# **NRC Public Meeting on NTTF 2.1 Seismic and Appendix H to NEI 12-06**

**October 21, 2015**

# Update on Appendix H to NEI 12-06

# Path 4 NRC Comment Responses

# Characterization of the Mitigation Strategy Seismic Hazard Information (MSSHI)

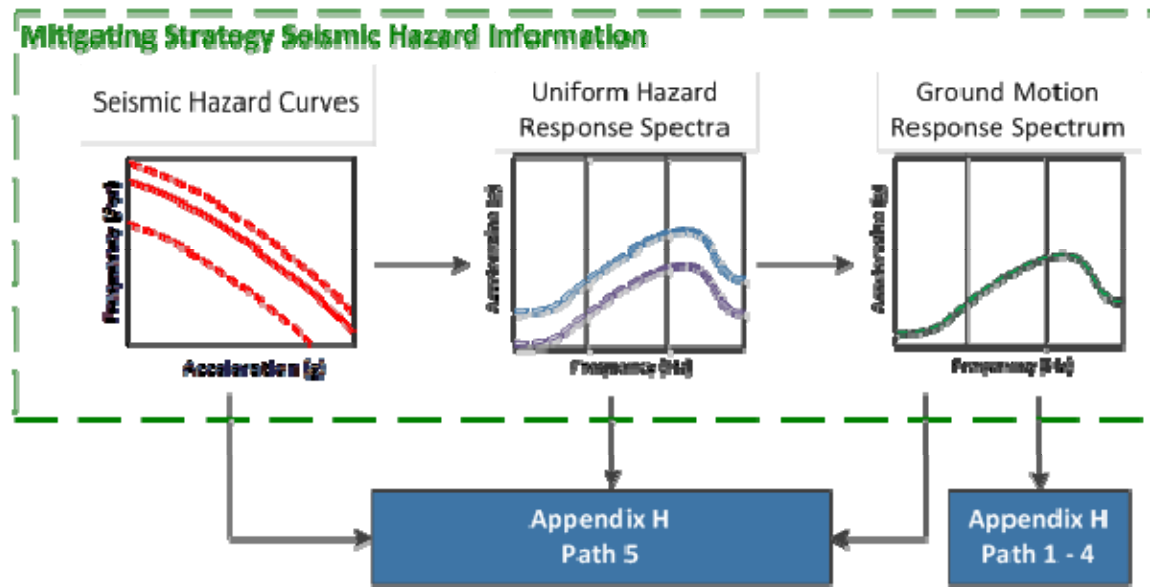
## Path 1: GMRS < SSE

- If the GMRS is bounded by the SSE spectrum at frequencies 1 Hz and greater, then additional evaluation is unnecessary as the FLEX strategies are reasonably protected to the MSSHI based on the underlying process used to develop the FLEX strategies.

## Path 2: GMRS > SSE at frequencies > 10 Hz

- For plants where the GMRS spectrum above 10 Hz exceeds the SSE spectrum, licensees can demonstrate adequacy of the mitigation strategy with respect to the MSSHI by performing an MSA that consists of an evaluation of HF sensitive in-plant SSCs required for mitigation strategy implementation.

# Path 3: GMRS > SSE - IPEEE demonstrates seismic capacity above GMRS

- If the high-confidence-of-low-probability-of-failure plant capacity spectrum developed from the evaluations for the Individual Plant Examination of External Events (IPEEE) envelops the GMRS between 1 and 10 Hz, an AMS may be used based upon the IPEEE.
- IPEEE safe-shutdown paths would be used to demonstrate reasonable protection of SSCs relied upon for this AMS.
- The MSA for Path 3 will address spent fuel pool cooling and high frequency
- While the Path 3 AMS does not generally rely upon availability of FLEX equipment, the MSA will address availability of FLEX equipment as a means of additional defense in depth.
- Alternatively, licensees may elect to perform an MSA of the impacts of MSSHI on mitigation strategies consistent with Path 4.
